UNITED STATES PATENT AND TRADEMARK OFFICE

| APPLICATION NO. | FILING DATE | FIRST NAMED INVENTOR | ATTORNEY DOCKET NO. | CONFIRMATION NO. |
|--|-------------|----------------------|-----------------------|------------------|
| 10/773,059 | 02/04/2004 | Bohumil Lojek | ATM-275 | 5441 |

| Office Action Summary | Application No. 10/773,059 | Applicant(s) LOJEK, BOHUMIL | |

Response To Amendment

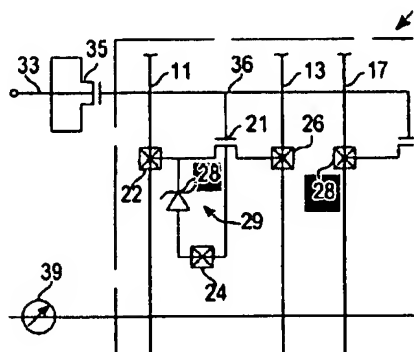
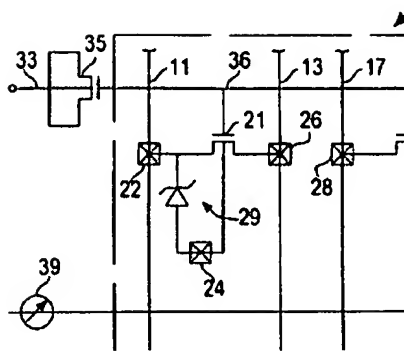
Fig.1 shows two components labeled 28 (the anode of diode 29; the contact on bit line 17). It appears that Applicant intended 28 to be the contact point (see Fig. 1 [connection of bit line 17 to EEPROM 23]; Fig. 2 [connection to EEPROM 23]); Fig. 3 & 4 [isolation region 82 of EEPROM 23; contact 28 of EEPROM 23]). Examiner recommends deleting label 28 pointing to the cathode of the diode on Fig. 1 (see suggested markup on top of next page).

NEW PROPOSED CORRECTION

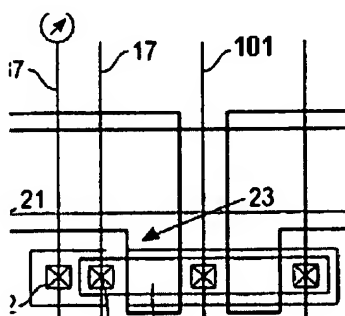
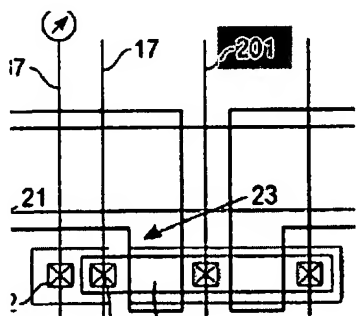
Fig. 4 shows unidentified line 201 (between 23 and 223). The specification indicates, "Shared line 101, a common electrode for memory transistor 23 and 223..." (page 10, line 31). Examiner assumes applicant intended to label said line of Fig. 4 as 101 (see suggested markup below).
